Corrib Gas Pipeline

Comments on the Advantica Safety Review

Leo Corcoran

20th December 2005

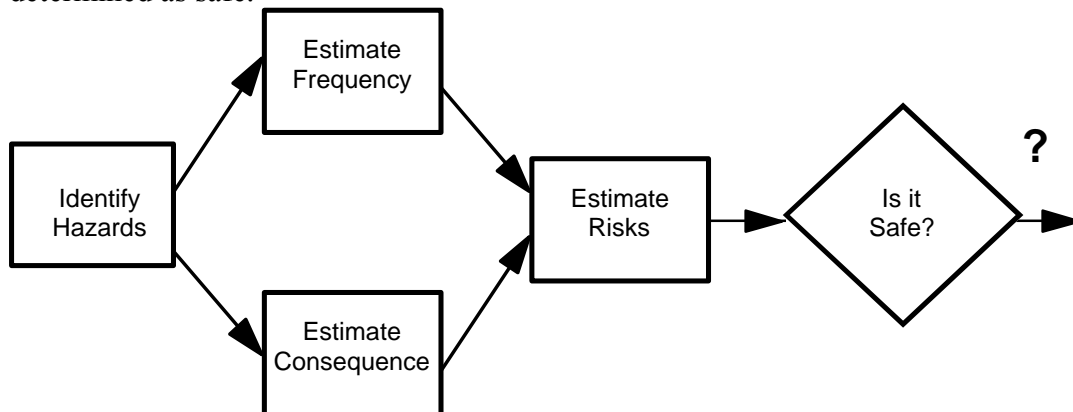
Classical QRA methodologies require the following analysis before a facility can be determined as safe.

The above analysis clearly requires the designer to have accurate and realistic historical data records on the failure frequency and event consequences. For the Corrib Gas Pipeline, operating at 345 bar, historical data sources are not available to enable a reliable and realistic QRA to be carried out.

For this reason QRA is not appropriate for this pipeline and therefore a more prudent and realistic prescriptive approach to the design, as recommended by Advantica and as contained in the codes of practice, should have been used.

Terminal Selection Process

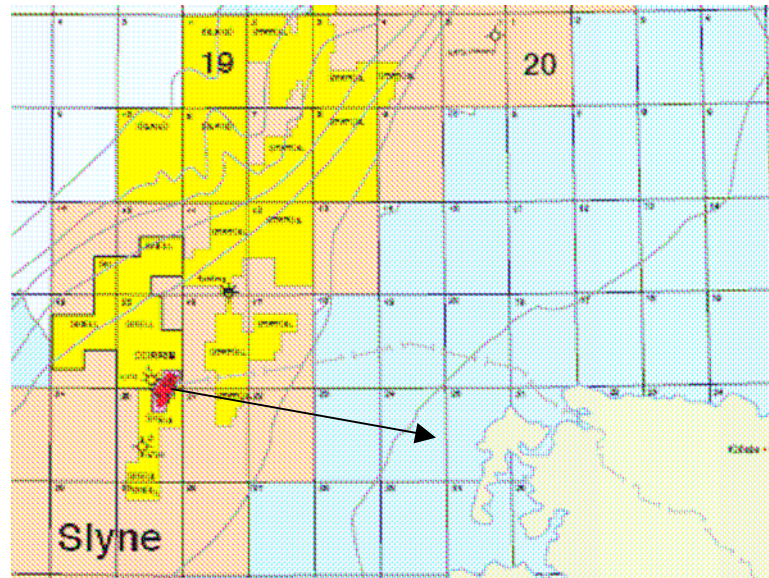
The selection of the Ballanaboy site should be reviewed given that the design of the upstream pipeline servicing the terminal is now different from the original. Advantica have now recommended a pressure limit of 144 bar and a design factor limit of 0.3. The location was also selected in advance of the Gas Act 2002 under which a more appropriate costal site could have been selected and acquired. Prior to the Gas Act 2002 the developer could not exercise CPO powers to acquire an optimum costal location for the terminal. The acquisition of the Ballanaboy site, from Coillte a Government agency, may have been a short term expedient, but it has shown itself to be a sub-optimal solution given the problems of routing upstream pipeline through populated areas unprecedented in pipeline practice.
